Bus links
Amendments to the operating instructions for DP/PA coupler, active field distributors, DP/PA

Product Information

08/2015
A5E35926358-AB

Figure 2-2 AFDiSD: Mode switch (factory setting "C" = compatible mode)

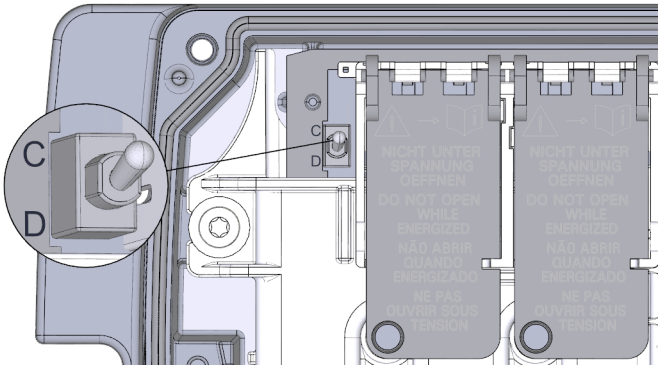
Particularities when using the AFDiSD

The AFDiSD described in this product information replaces the predecessor.

Make sure in this application that the mode switch of the AFDiSD is set to the compatible mode (switch position = "C"). The mode switch can be found (in top view) to the left of the IP30 covers.

Figure 2-4 Rules for connecting trunk lines in hazardous areas

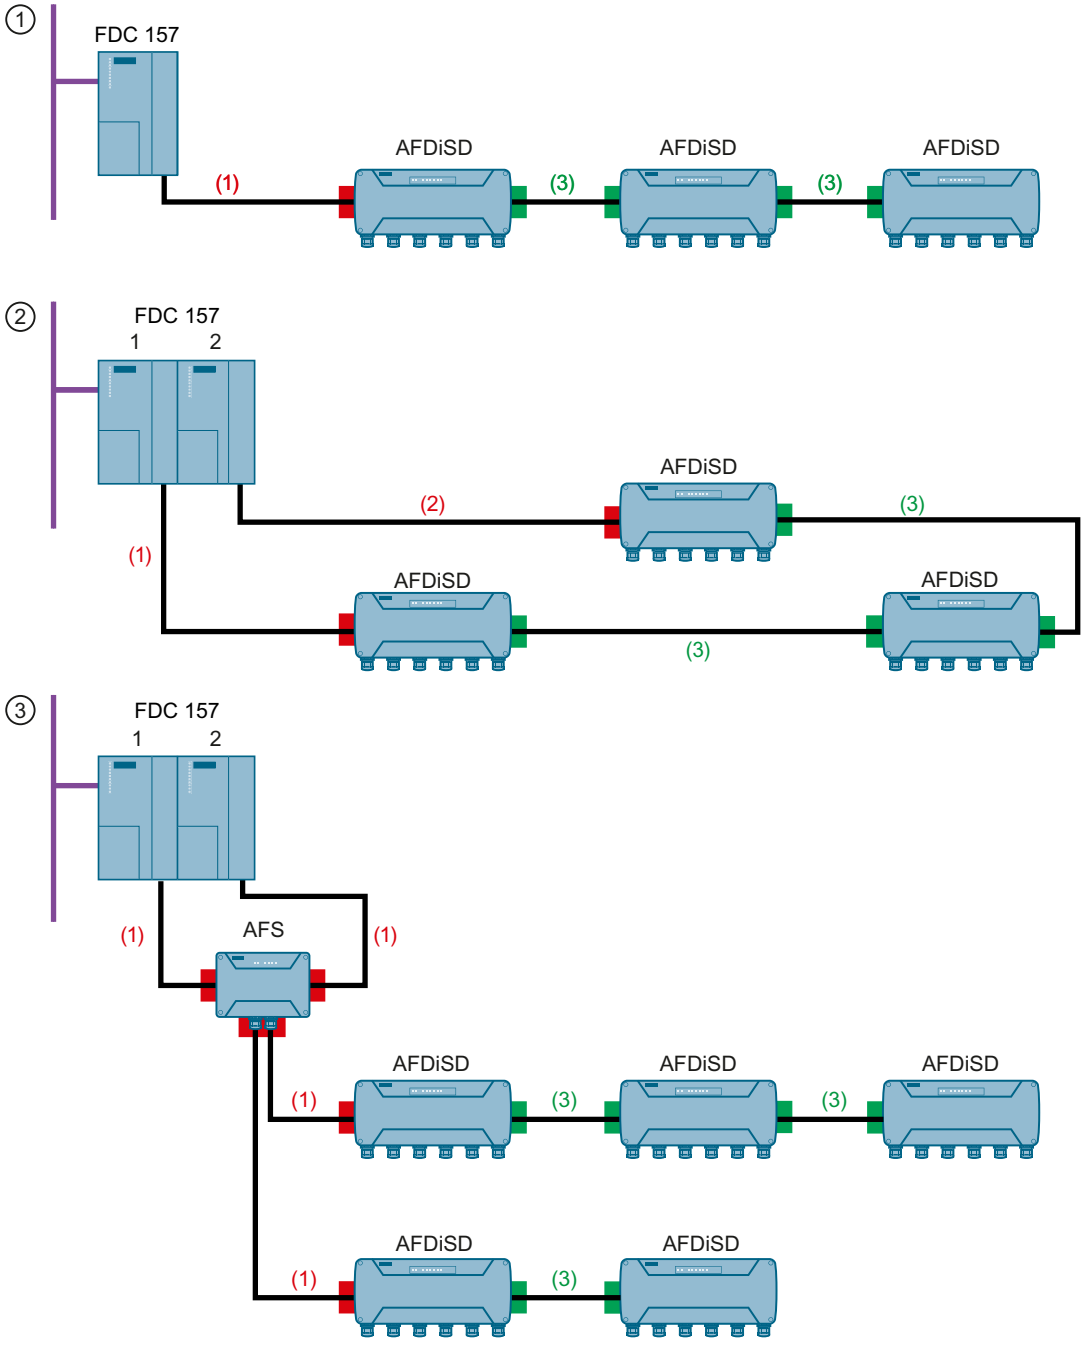
When connecting trunk lines in a zone 2 hazardous area, please comply with the following rules:

No.	Rule
①	FDC must be disconnected from the voltage supply when disconnecting the line (1) on the AFDiSD
②	FDC 1 must be disconnected from the voltage supply when disconnecting the line (1) on the AFDiSD FDC 2 must be disconnected from the voltage supply when disconnecting the line (2) on the AFDiSD
③	FDC 1 and FDC 2 must be disconnected from the voltage supply when disconnecting the line (1) on the AFS and AFDiSD

- Connection of the lines (3) is possible during operation
  (marked green in the figure above)
- The spur lines S1 to S6 can always be connected during operation.

Figure 2-9 Startup characteristics of the IM 153-2 after POWER ON

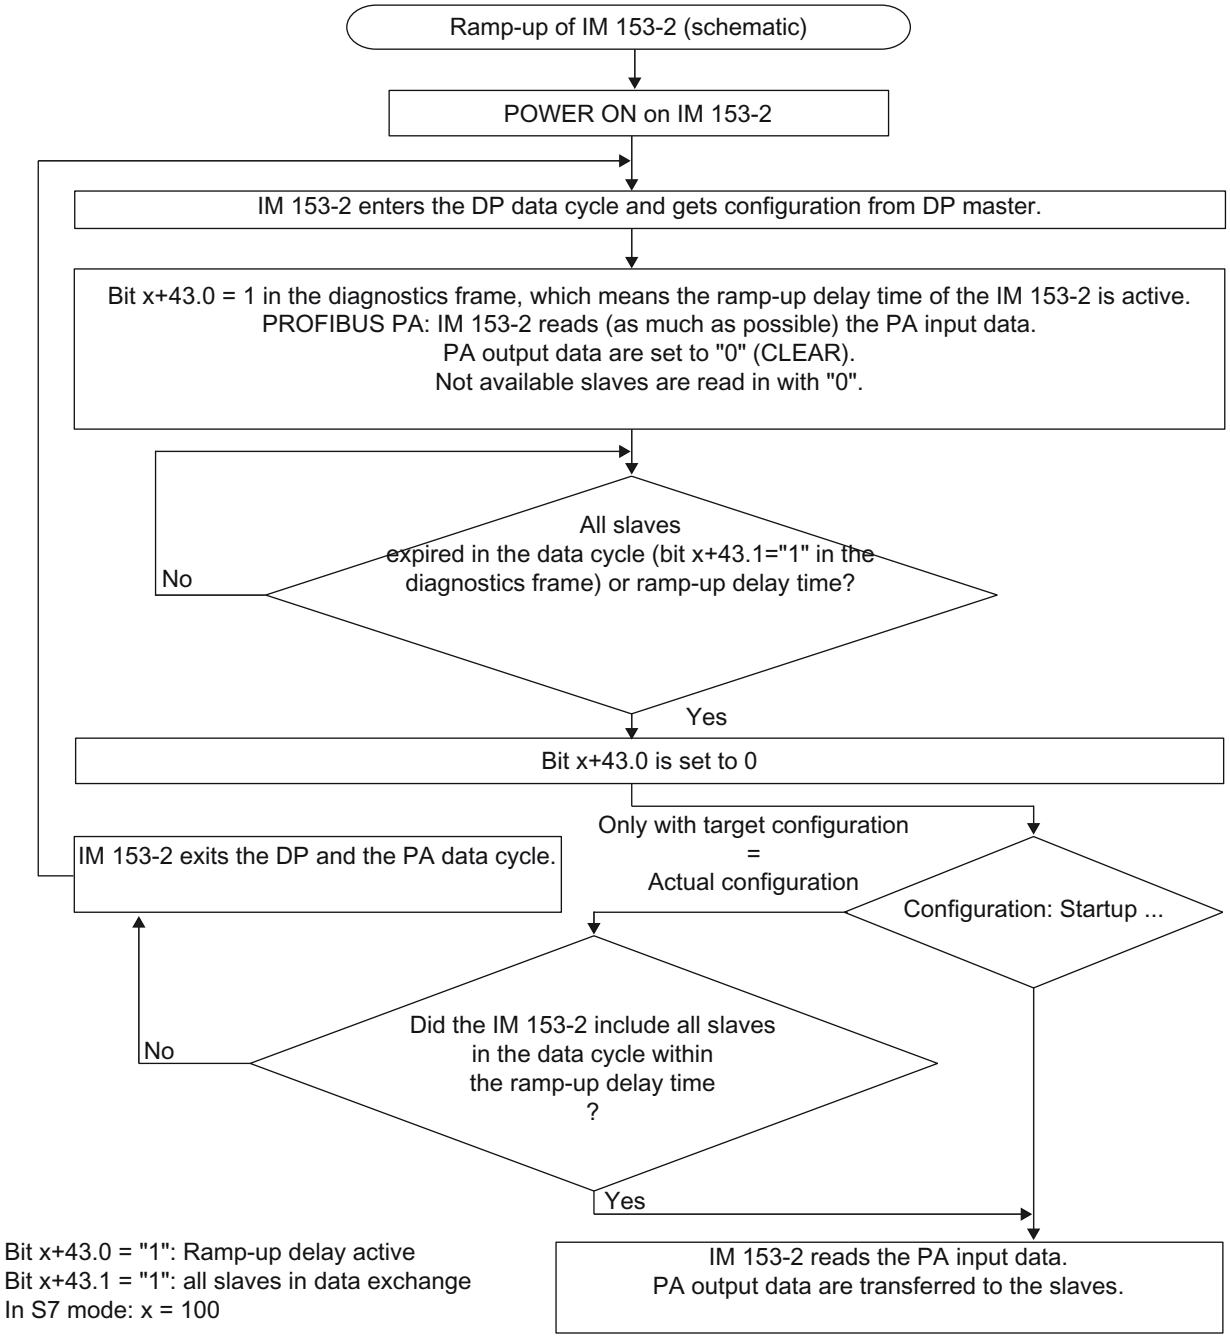
The flow chart "Startup characteristics of the IM 153-2 after POWER ON" contains a display error. The correct version is:
